2009 MOTO

Main Pivot Assembly Update

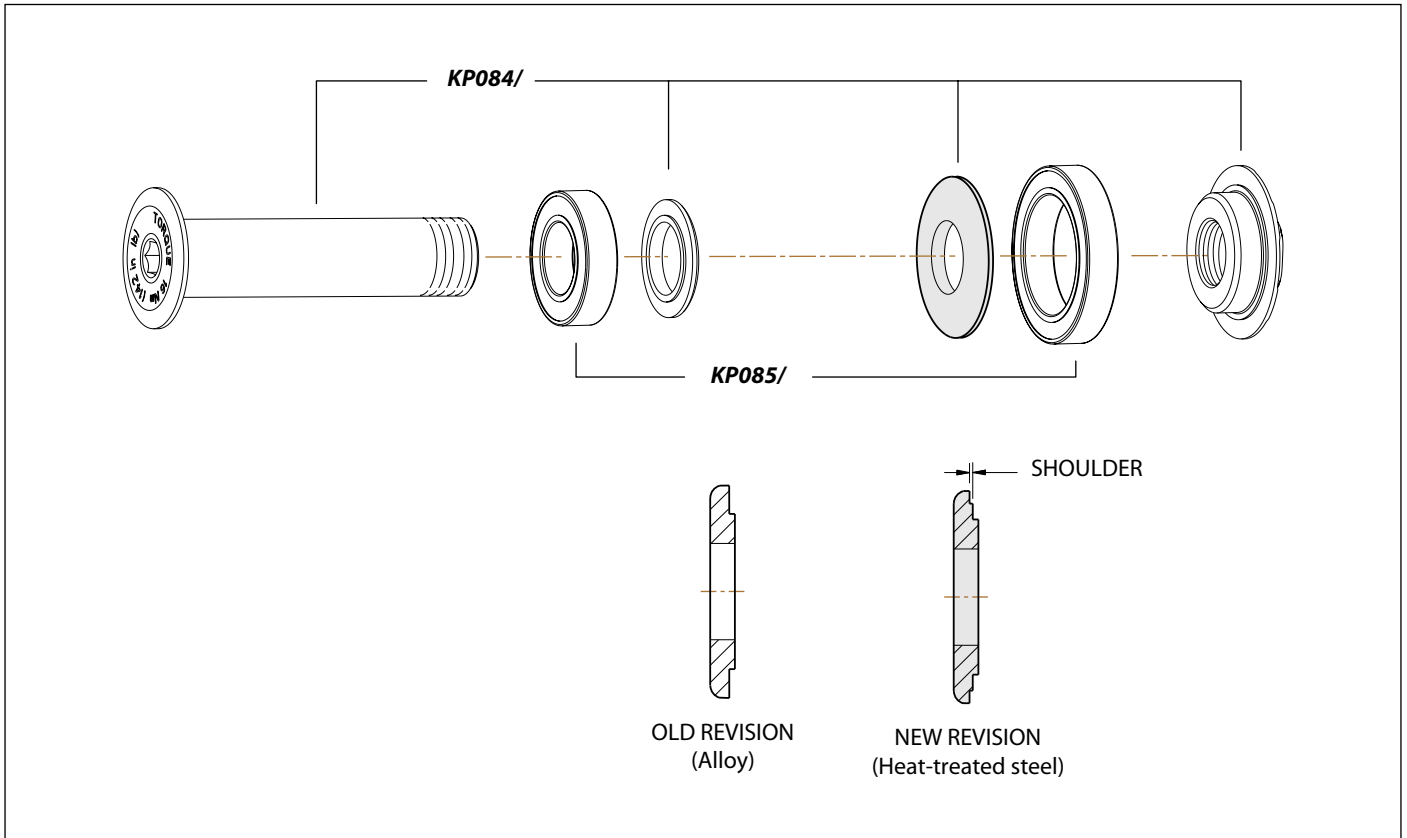
The non-drive side pivot spacer (shaded above) of both MOTO Carbon and MOTO Alloy frames has been updated. The part material has been changed from alloy to heat-treated steel and a small SHOULDER to fit against the non-drive side bearing. The new revision spacer will be less susceptible to damage from over-torquing the main nut (item 6). The new spacer design can be identified visually without disassembly since it is bronze in color and magnetic. The older revision spacer is silver in color and is non-magnetic. The new revision spacer is included in Cannondale kit **KP084/**.
